ENVIRONMENTAL REVIEW TEAM REPORT

**WESTPORT
CONDOMINIUMS**

**WESTPORT,
CONNECTICUT**

MAY 1986

**CONCEPTUAL
SITE PLAN**

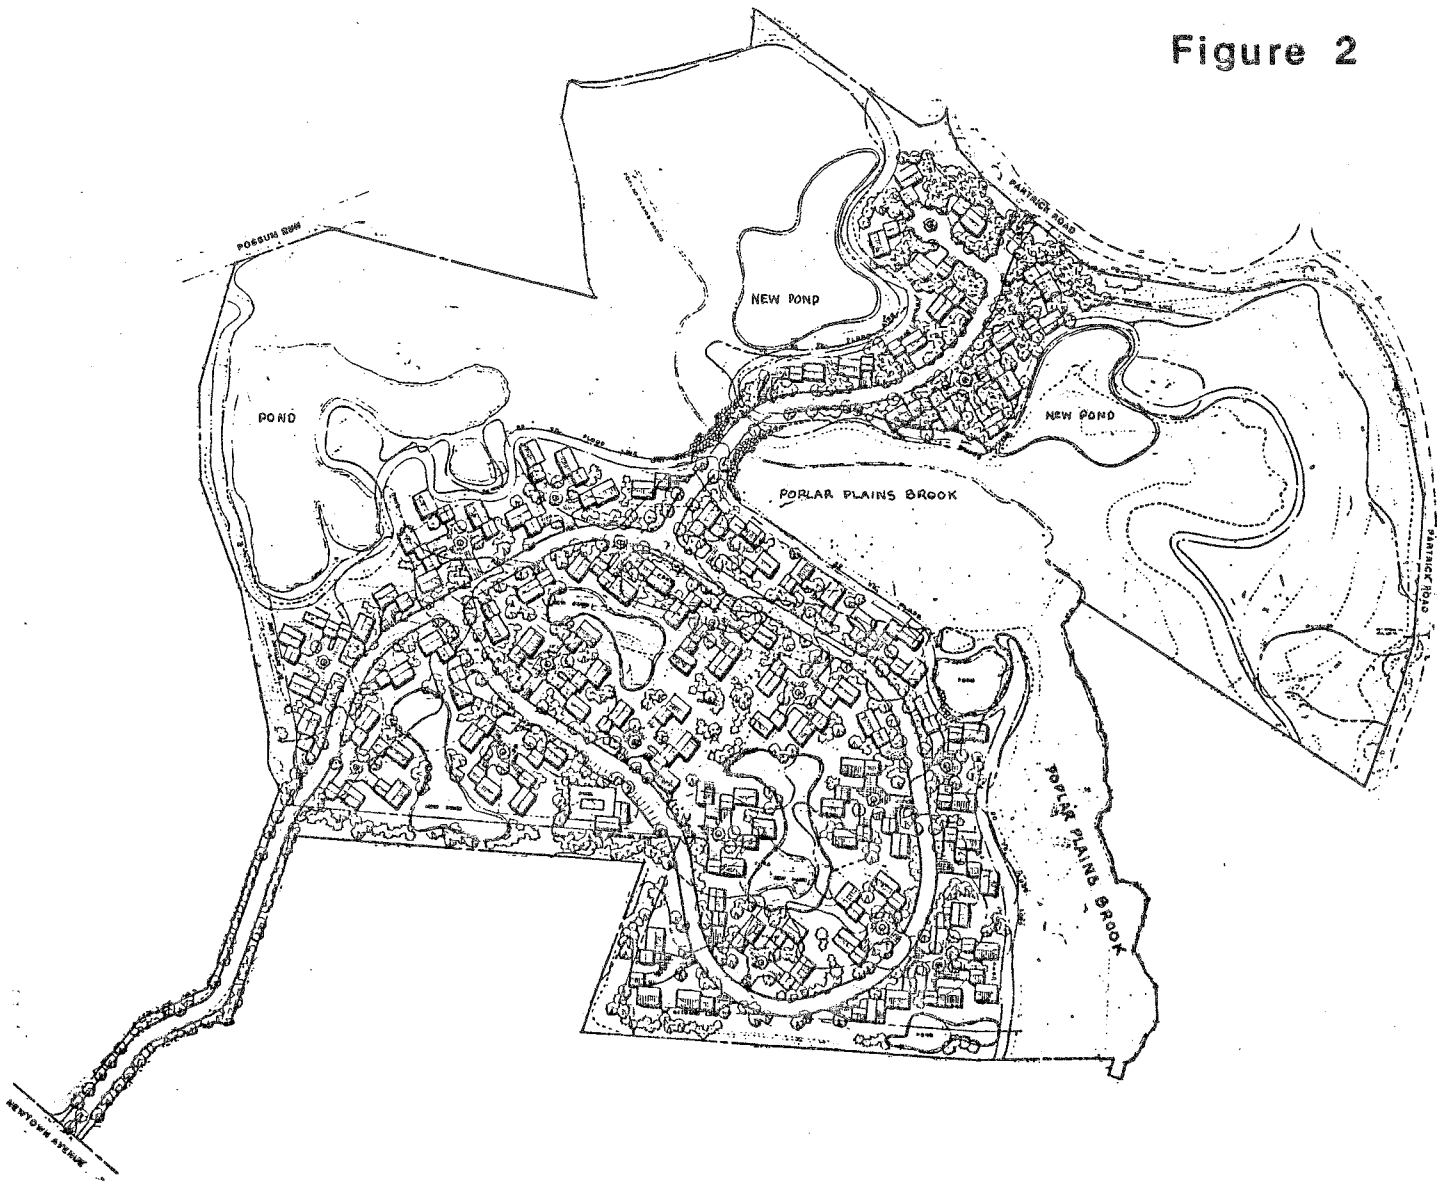
Plans provided to the Environmental Review Team showed that the proposed 100-unit condominium development would entail several types of wetland involvement. Three ponds within the udorthent area will be filled. Two ponds in the western portion of the site will be enlarged, and two new ponds will be created in the udorthent and upland area. Two additional ponds are to be excavated within the flood plain. The two ponds numbered in Figure 9 are to remain essentially unaltered. A road is to be constructed across the flood plain and Poplar Plains Brook to connect development on the east portion of the site with the areas to the west of the brook. Fill would be placed in approximately 22.7 acres of wetlands. (The applicant's report to the Conservation Commission stated that, while 22.7 acres of wetlands would be filled, only "...9.4 acres of regulated area are involved." The understatement of the regulated wetland acreage is apparently based on a misunderstanding concerning aquatic udorthents. Many areas which were filled prior to the passage of the Inland Wetlands and Watercourses Act are not regulated as inland wetlands. However, where fill areas remain under an aquatic regime, i.e., if aquatic udorthents are present, the area is regulated

- (8) Since the applicant's plans do not show the extent of the 100-year floodway, it is difficult to assess the safety of the development during a low-frequency storm. Since the plans show development extending up to the 25-year floodway, it is easy to assume that roadways and homes will be located in the 100-year floodway. Not only is there the danger of property damage, evacuation routes could be flooded out if the access roads are constructed below the 100-year flood elevation; and

The applicant had asked whether the proposed development would destroy or adversely affect any valuable wetlands. The short answer to this question is "yes." Of particular concern are the activities proposed for the flood plain which are to include two ponds and a roadway crossing. The wetland quality is such that filling should be limited to the minimum amount necessary, and if it is possible to develop the site without crossing the wetlands, impacts could be substantially reduced.

There is an old saying that goes, "If it ain't broken, don't fix it." The flood plain wetlands are far from broken and certainly do not require fixing. The two ponds slotted for excavation in the flood plain have been supported in the developer's documents in terms of improving habitat diversity. There are already ponds on-site, however, and the two ponds which the developer has planned not to disturb are in close proximity to the flood plain. These ponds are not isolated entities. Together with the red maple swamp, they provide wildlife habitat. Excavating additional ponds within the flood plain is not necessary.

Any development plan for this site should be designed with wetland conservation and flood protection in mind. Encroachments into the red maple swamp in the flood plain should be avoided. To ensure that the site will be aesthetically pleasing while still able to support waterfowl, some ponds should be provided. Measures which would mitigate the adverse impacts of the development proposal include:

- (2) Cuts and fills should be balanced within the 100-year floodway;
- (3) At a minimum, structures and fill should encroach no further into the floodway than those shown on the plans;

- (4) Plans should provide dry evacuation routes during low frequency storms;
- (5) A vegetated buffer of at least 25 feet should be maintained between the flood plain and the proposed condominiums;

- (6) Erosion checks should be placed at proposed toes of slope to prevent entry of sediments into wetlands or watercourses;
- (7) It is suggested that fill slopes be no steeper than 1:1. Embankments should be immediately seeded and mulched to prevent erosion, and staked haybales or silt fencing should be maintained until grass plantings have begun to stabilize slopes;

- (10) The new ponds and pond enlargements should be designed to attract waterfowl and songbirds. The ponds need only be five feet deep or so, and should have gentle side slopes of about 4:1 to ensure stability and to enable emergent vegetation, floating aquatics and rooted aquatics to become established in the shallows at the pond margins. It is this vegetation which will attract and support waterfowl. A "shelf" should be designed in the basin perimeter, where water depths would be no greater than one foot. The shelf should be planted with such moisture-loving plants as cattails, Italian rye, water millet, wild rice, wild celery, arrowhead, common bullrush, and cardinal flower to provide nesting and forage material for ducks, shiners and songbirds. An appropriate planting of berry-producing wetland shrubs should be planted landward of the marsh fringe to support songbirds. Such a planting could include bayberries, arborvitae, highbush blueberry, virburnums, and silky dogwood;

Figure 8

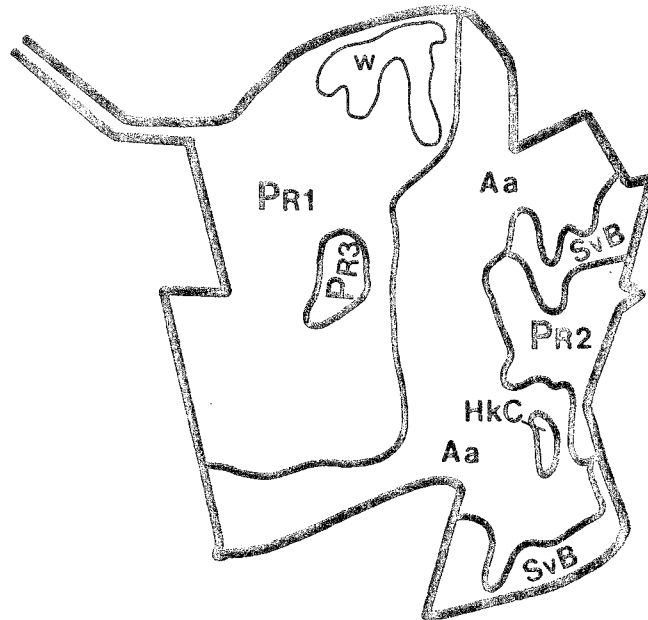
This map unit is composed primarily of Palms soils on 0 to 3 percent slopes. Palms soils are very deep and very poorly drained. Typically, they have an organic surface layer 16 to 51 inches thick overlying loamy materials to a depth of 60 inches or more. The water table is at or near the soil surface for the majority of the year. These soils are inland wetlands (Figure 8).

This map unit is composed primarily of Hinckley soils on 3 to 15 percent slopes. Hinckley soils are very deep and excessively drained. Depth to the water table is greater than 6 feet. Hinckley soils have stratified sand and gravel to a depth of 60 inches or more (see Figure 8).

This map unit is a former borrow area composed of shallow soils and rock outcrops. The soils are less than 20 inches deep over bedrock. Slopes range from 3 to 40 percent. Any cuts into this material will require blasting.

Figure 9

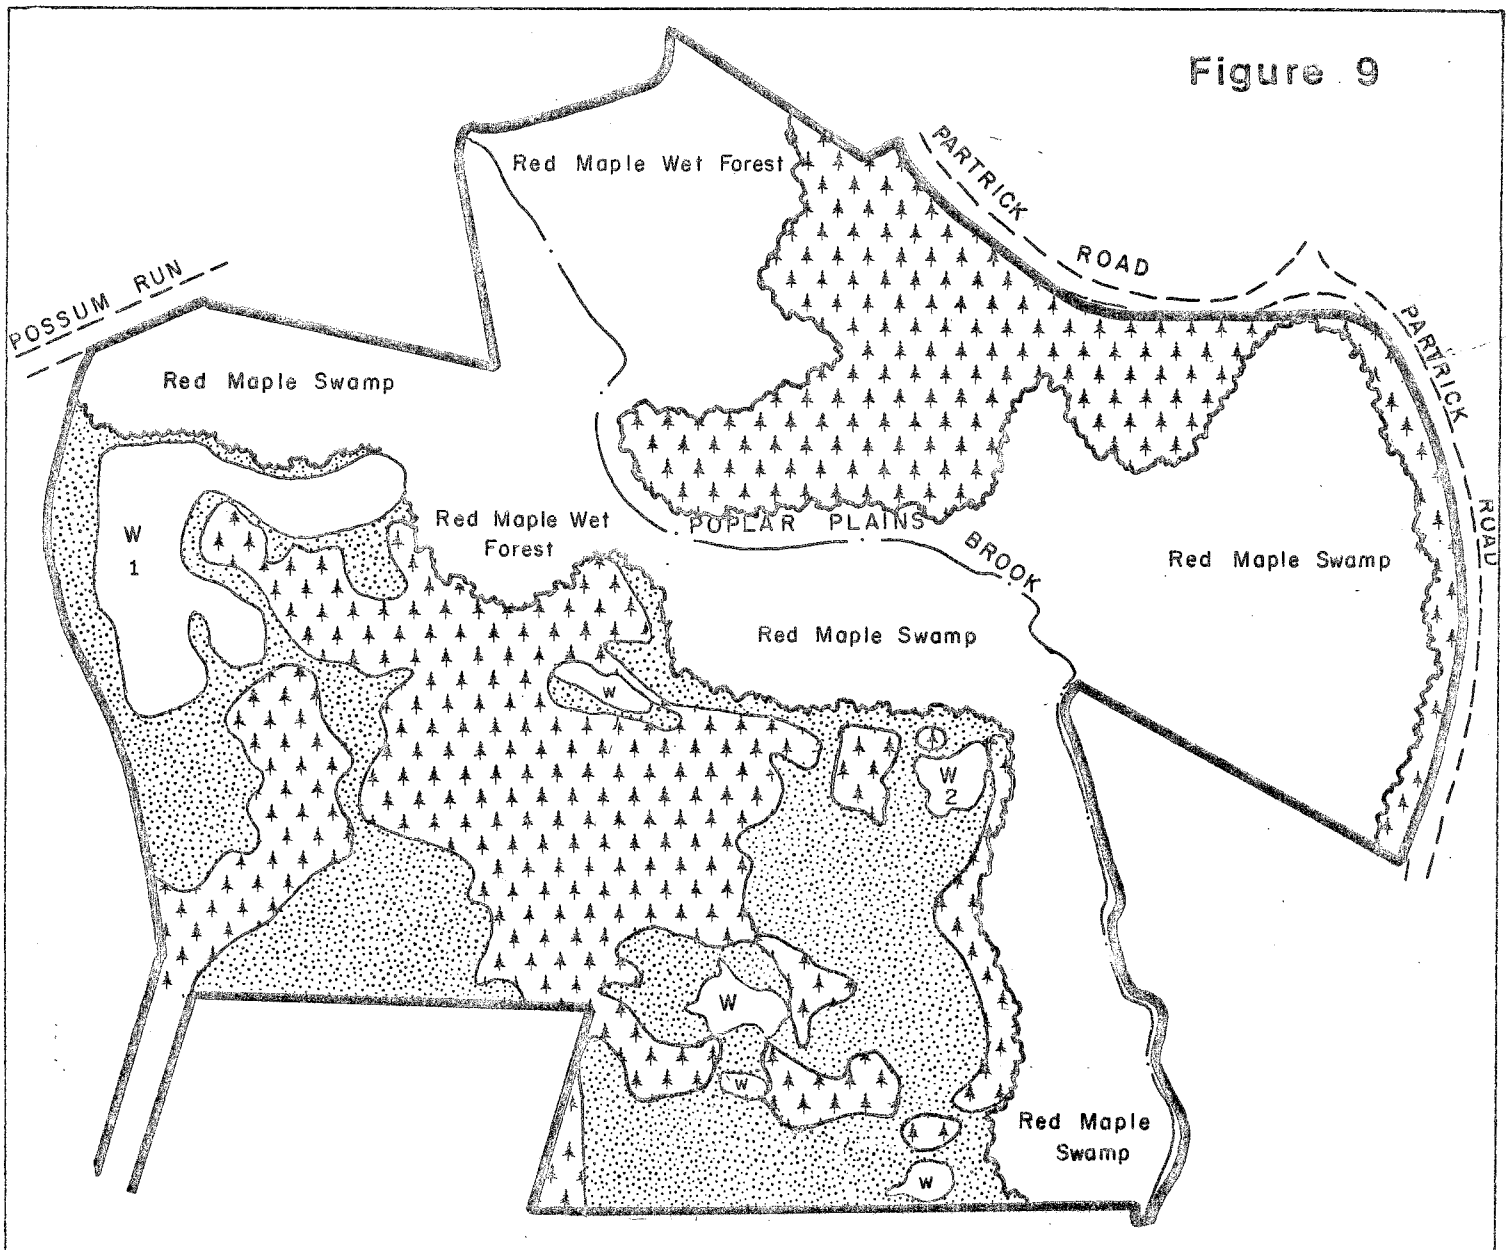
Perhaps the most noteworthy of the ponds is the one labelled number "1" in Figure 9. Roughly 1.9 acres in extent,
